297 Cumberland Ave.
Building Addition
Salvation Army

TO: Jean Fraser, City of Portland Planner
FROM: Dan Goyette, PE – Development Review Engineer, Woodard & Curran
DATE: November 28, 2006
RE: Salvation Army Building Addition

Re: Salvation Army
297 Cumberland Avenue
Site Plan Review – Comment Response (Fraser Letter of 11/22/06)
SMRT Project No. 05023

PLANNING BOARD REPORT # 04-07

CP101 4a

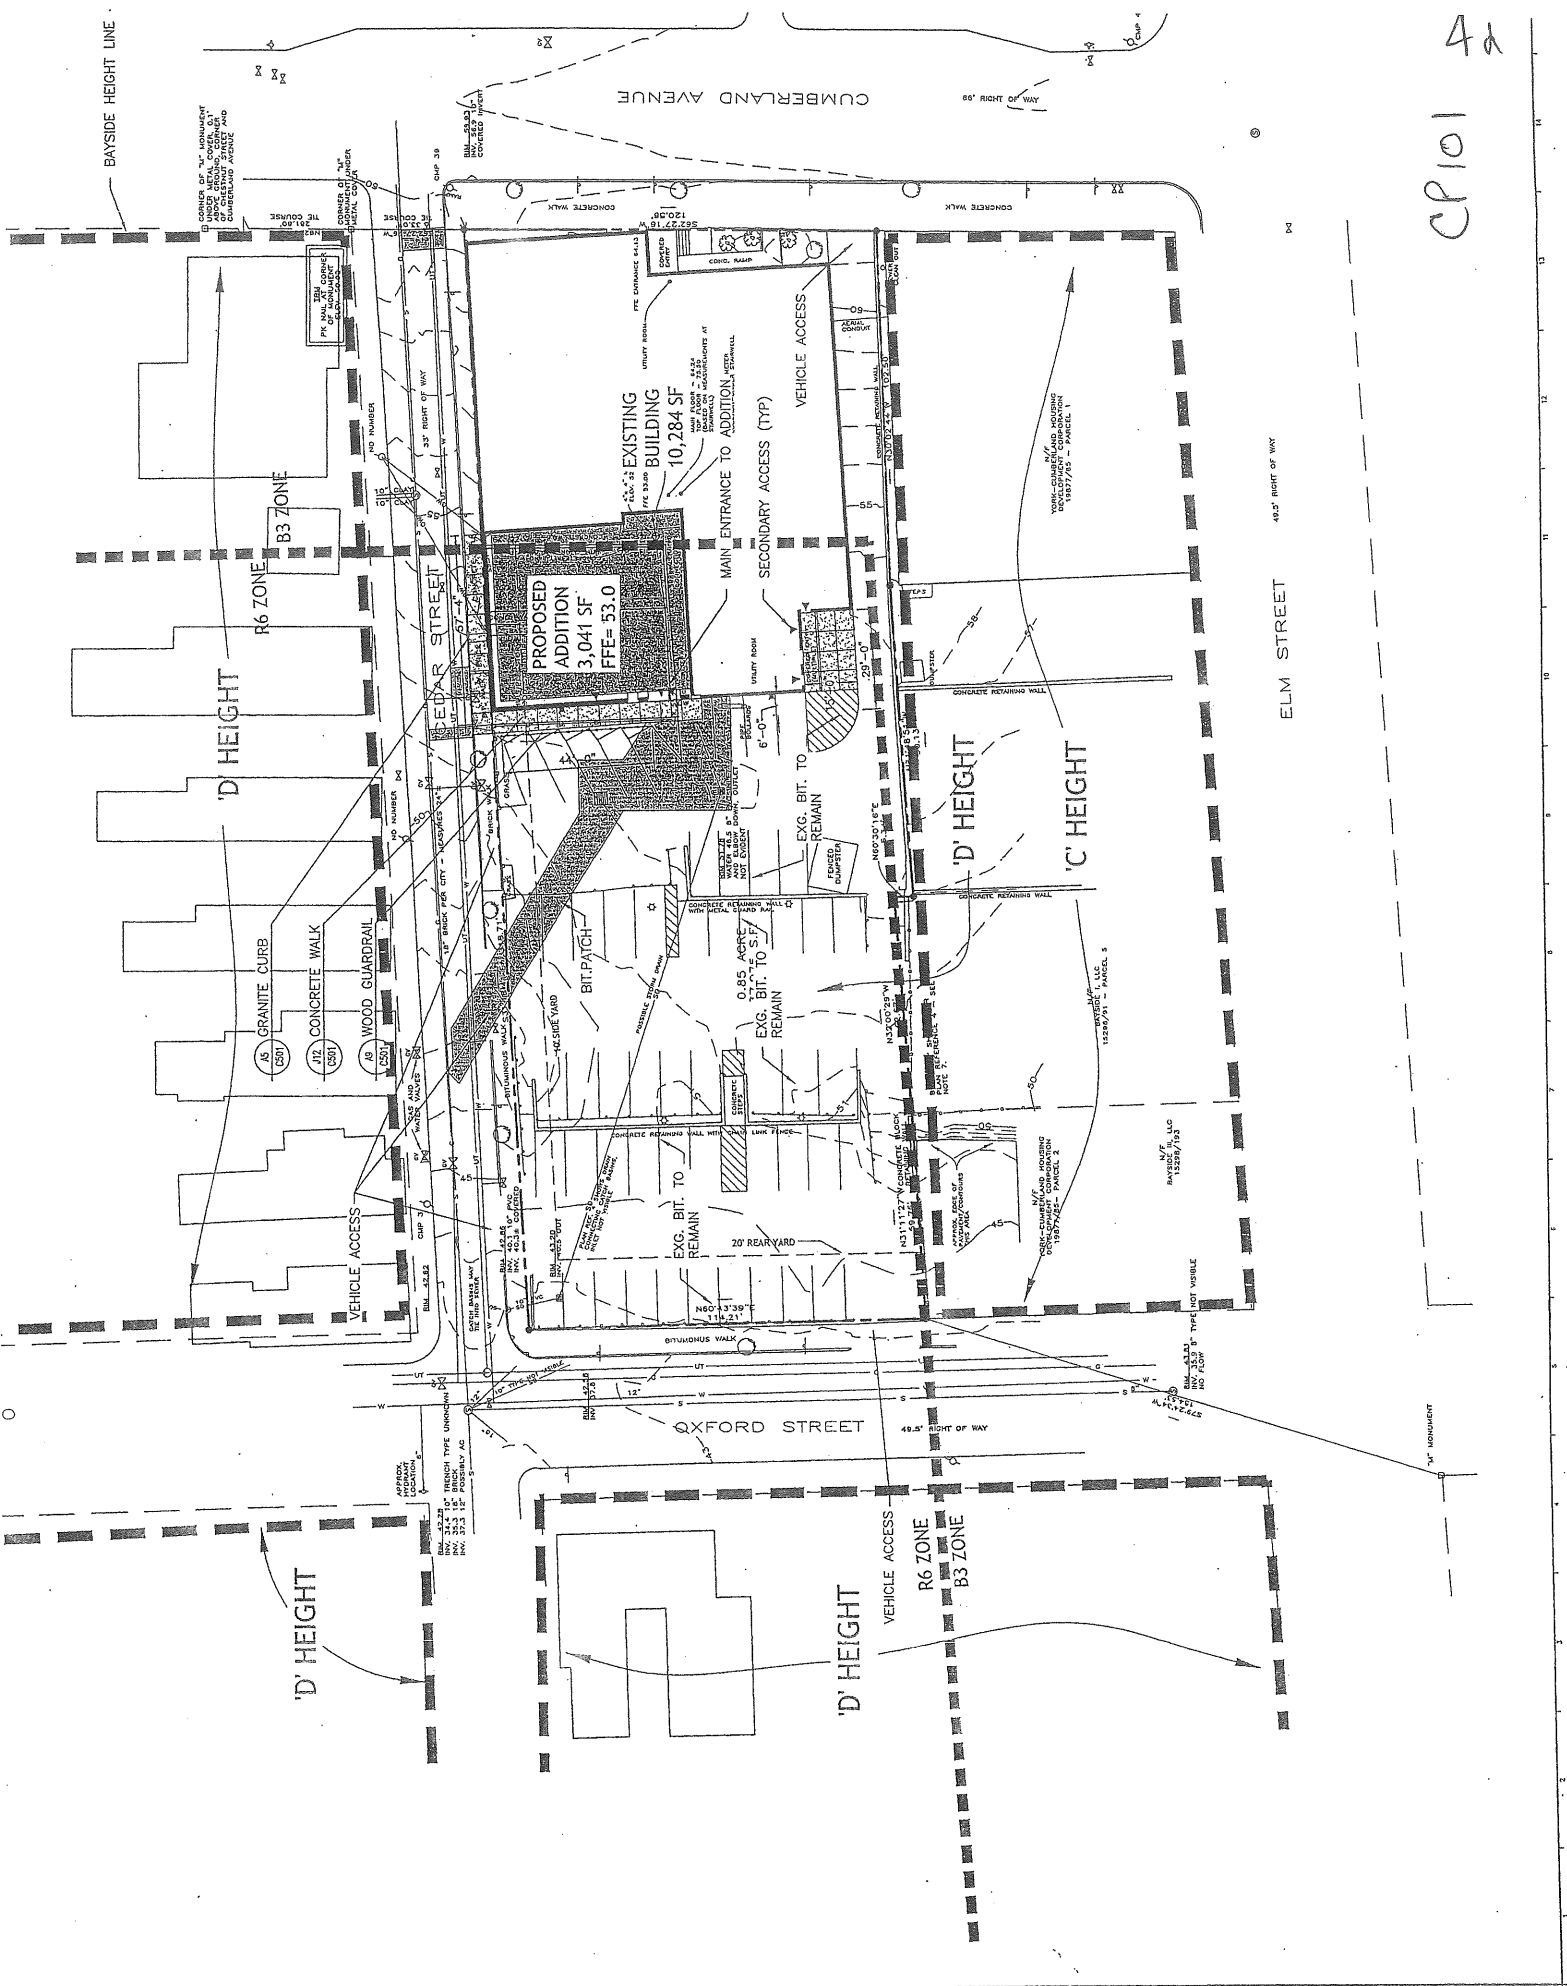
Regarding the zoning lines that you overlaid on the Layout Plan, how did you arrive at those? The reason I ask is that Rick Knowland and I reviewed the zoning and height overlay plans in relation to this site and thought that the B3 line was just at the back of the existing SA building along Cedar Street (ie that the building addition was totally within R-6). So could you clarify on that please.

SCALE: 1"=20'
CAD FILE: 05023_CG101
PROJECT No. 05023
REF. SHEET: CG101

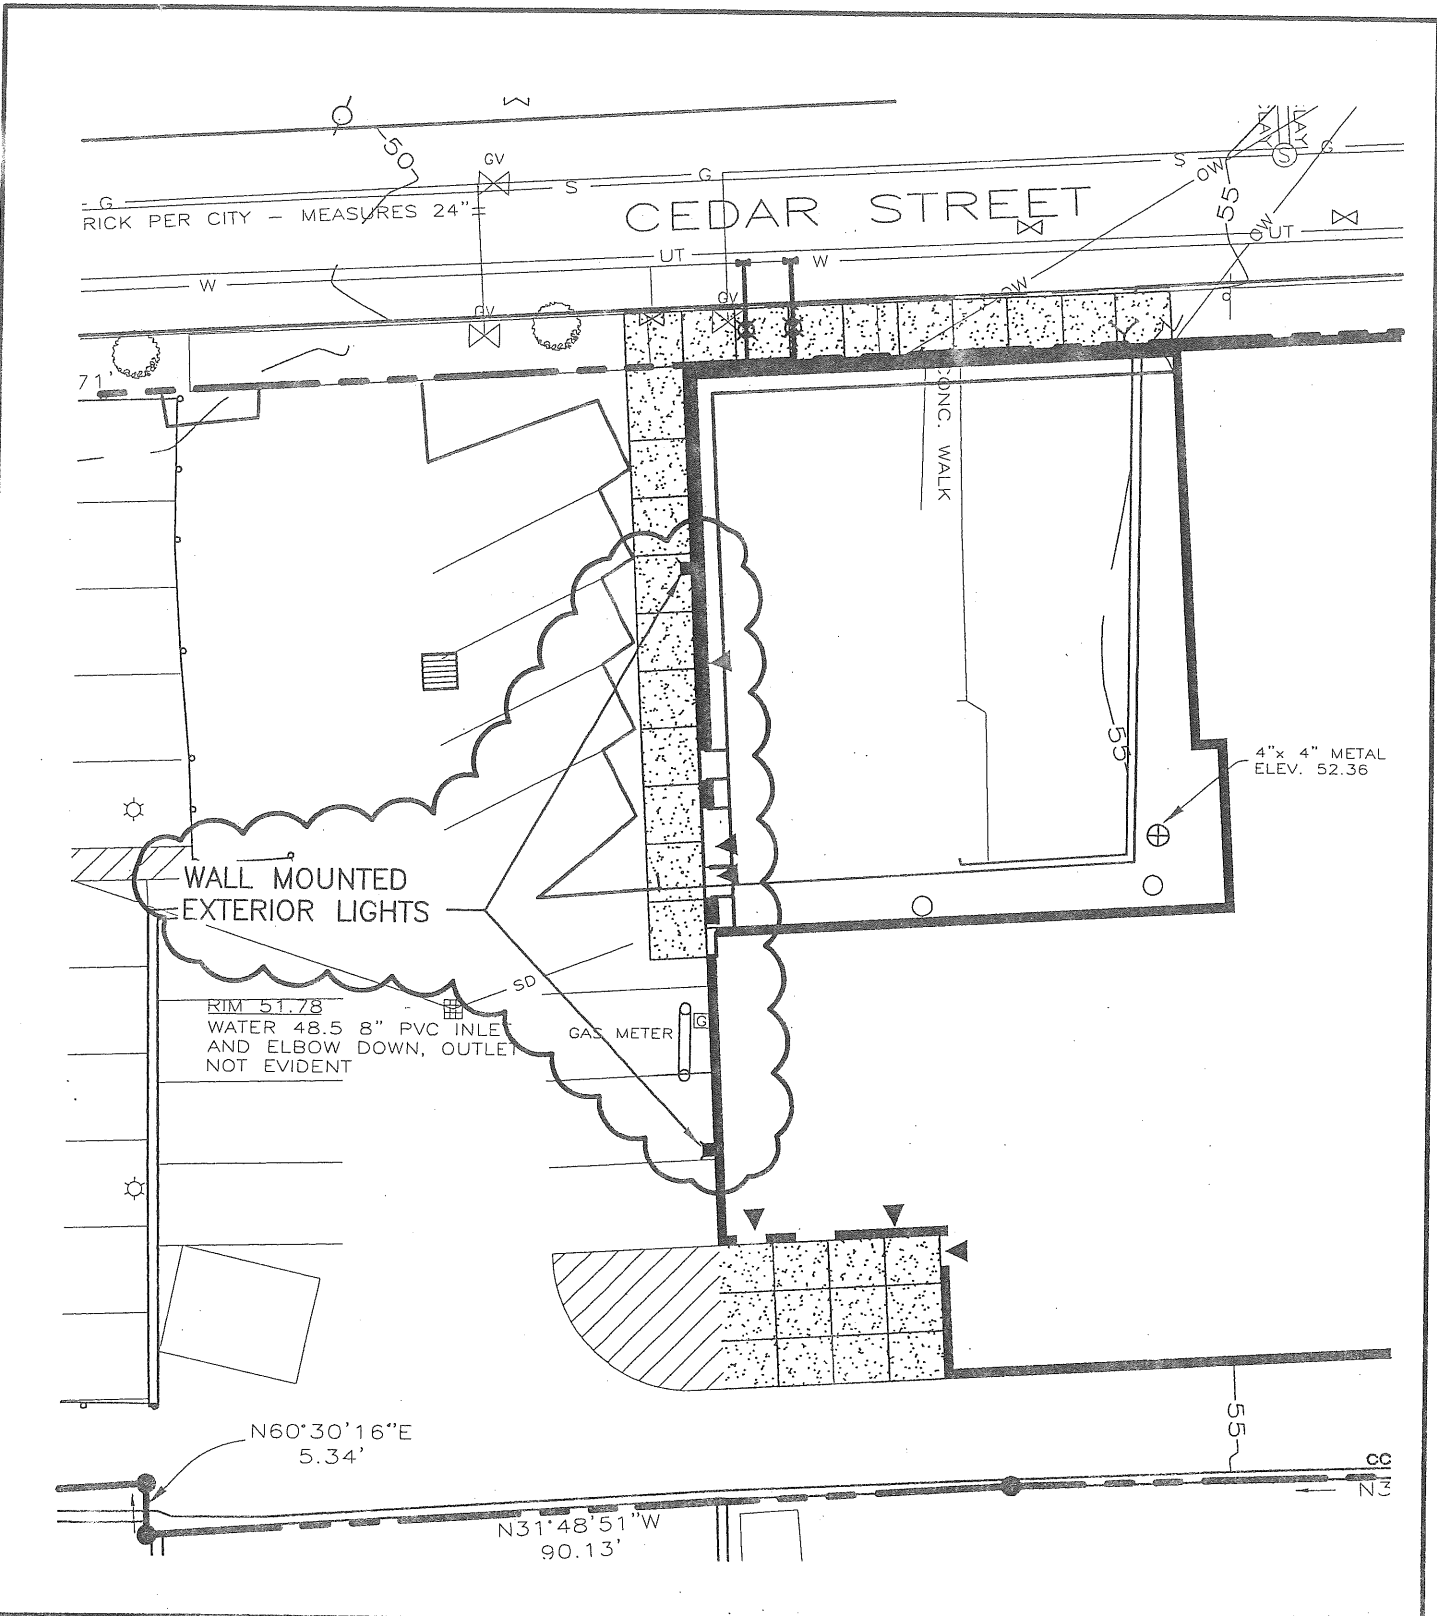
- Detail A5 should indicate a 7” granite curb reveal.
- Detail A12 should indicate a 3’ sump and a precast concrete base.
- Detail E12 should indicate 6” of stone under sanitary and storm lines, 12” of stone over sanitary and storm lines, 15” of type “D” gravel in the roadway and 3” of type “B” gravel..
- A detail should be provided indicating how the existing storm drain lines in the parking lot will be abandoned.
